Re: ED-26-53

**Request for Declaration Regarding Development/Exempted Development at
Drumlowan, Gortvagh, Co. Leitrim N41 R899.**

Applicant: Aidan Cafferty

Further Information

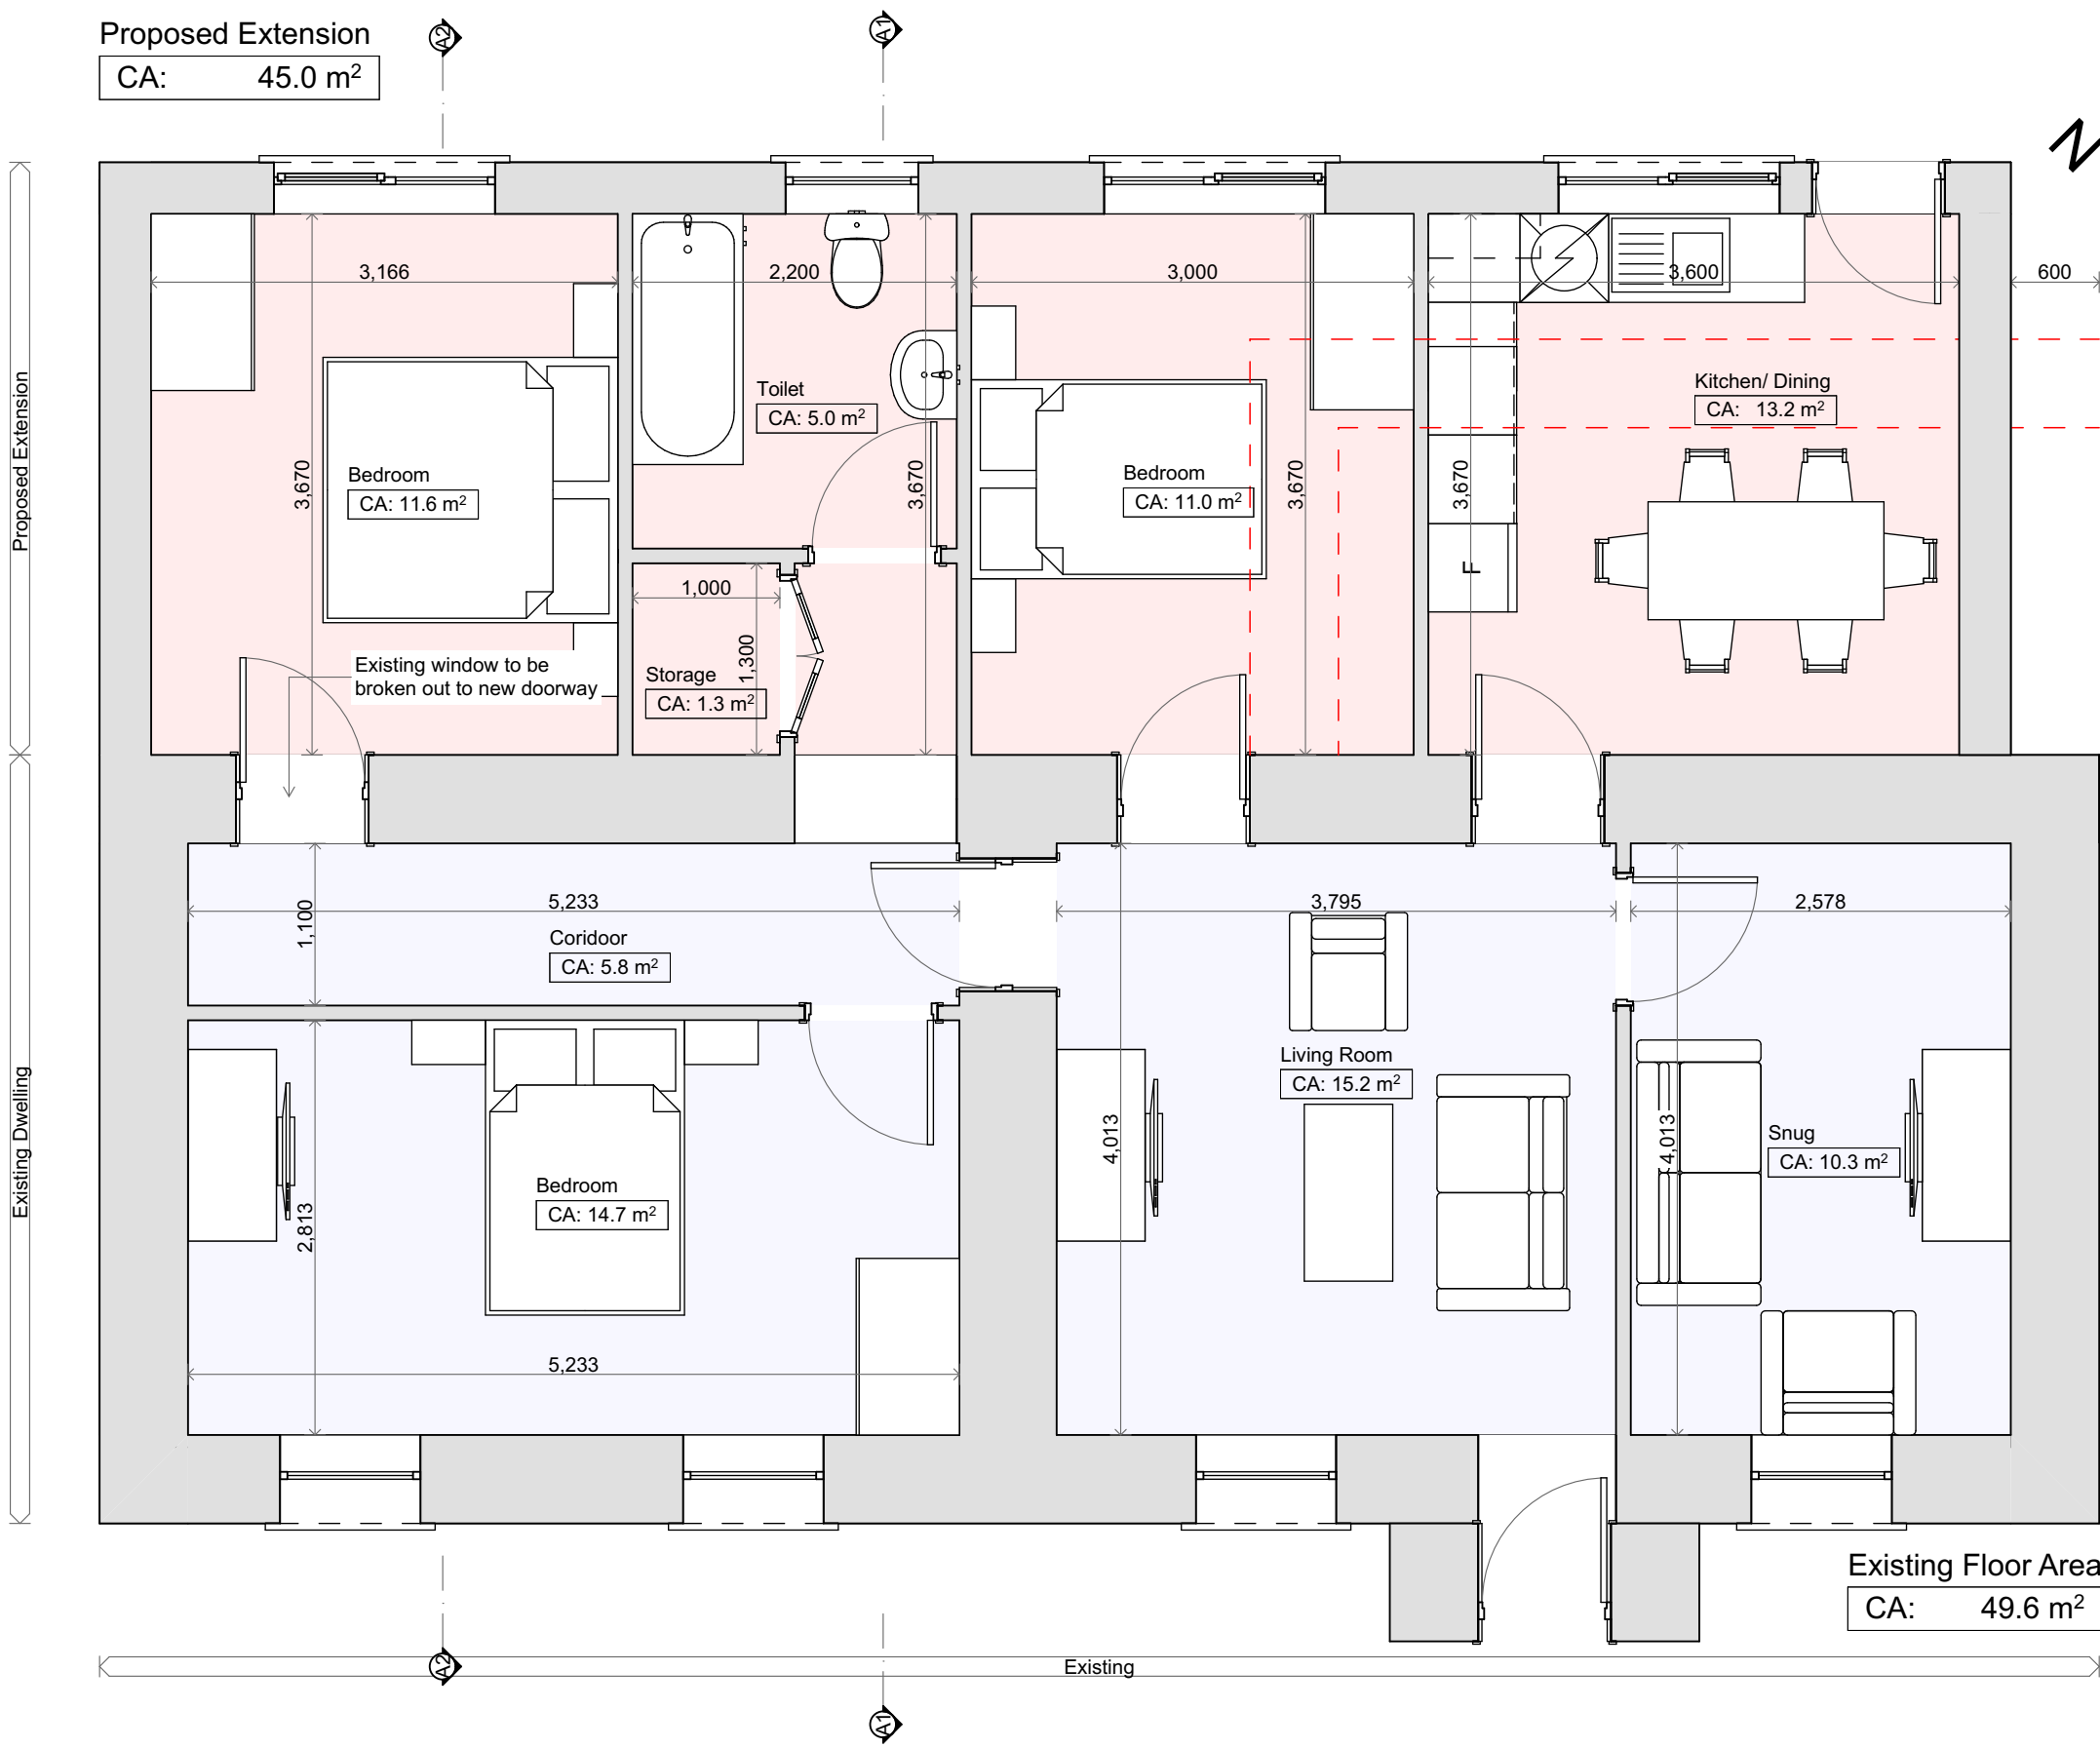
1. The site layout plan and floor layout plan do not accurately depict the extent of the existing rear extension. The documentation submitted with this referral identifies the rear extension as 'pre 1964 construction'. It is unclear whether this is the case as the southwestern portion appears as a bathroom addition on foot of the 1971 planning permission for a septic tank. The southeastern portion is a more recent addition. You are requested to submit the total floor area of the existing as-built rear extension in its entirety.

Response: Please see attached FI26-037-001 Proposed Floor Plans- for updated floor plan and floor area. Please note that all the rear extension is now 45m².
